VICTA AVIATION DIVISION

SERVICE LETTER No. 65/2.

METHOD OF REPAIR, BAG TYPE FLEXIBLE FUEL TANKS.

SERVICE LETTER NO. 64/5 23/4/64

Fig. 1

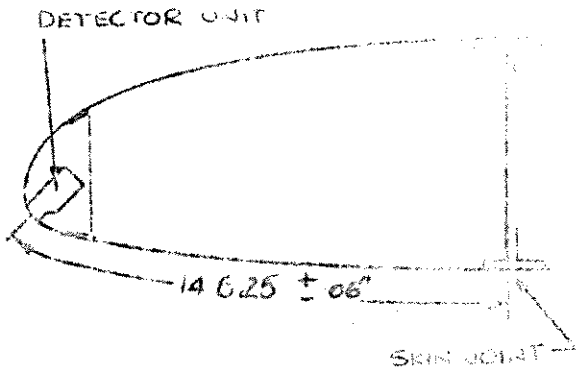
1. A check on the position of the detector vane around the profile may be obtained by measurement along the contour between the bottom edge of the vane and the skin join on the bottom surface at the spar, refer Fig. 1.

Ensure that the detector is at the mid-point of its adjustment when measuring. The position of the skin join is not jigged, however, production techniques are such that it may be used as a reliable and easy check on the method to position the detector as shown on Victa Drg. No. 02-03075.

Fig. 2

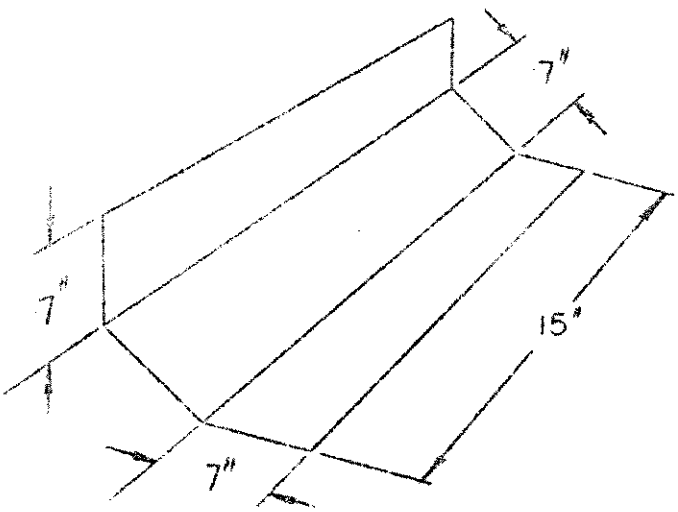
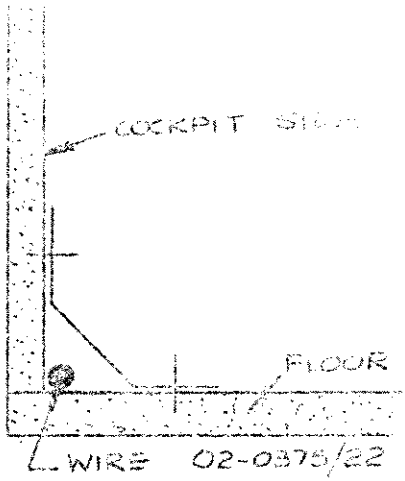
4 Protection for wire, Part No. 02-0375/22, against damage from shoes in the area where it runs along the cockpit floor may be provided by a guard as shown, Refer Fig. 2 & 3. Bend up from 22 or 24 SWG aluminium alloy, and rivet in place between the floor and cockpit side using [illegible] pop rivets at 3" pitch.

FIGURE 1

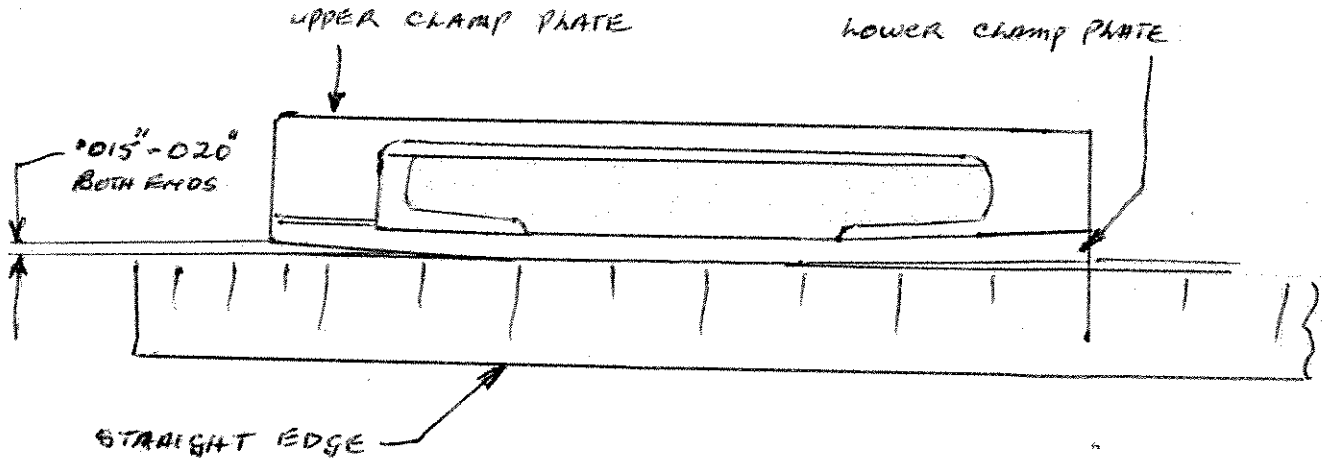
(b) Place a straight edge along the underside of the lower clamp plate and by means of feeler gauges at each end of the clamp plate measure the bow. (See Figure 1 - Sheet 3).

(c) If the gap at either end of the clamp plate is less than the figure shown remove sufficient shim washers from between the plates to achieve this dimension when the bolts are torqued to 216 - 240 inch lbs.
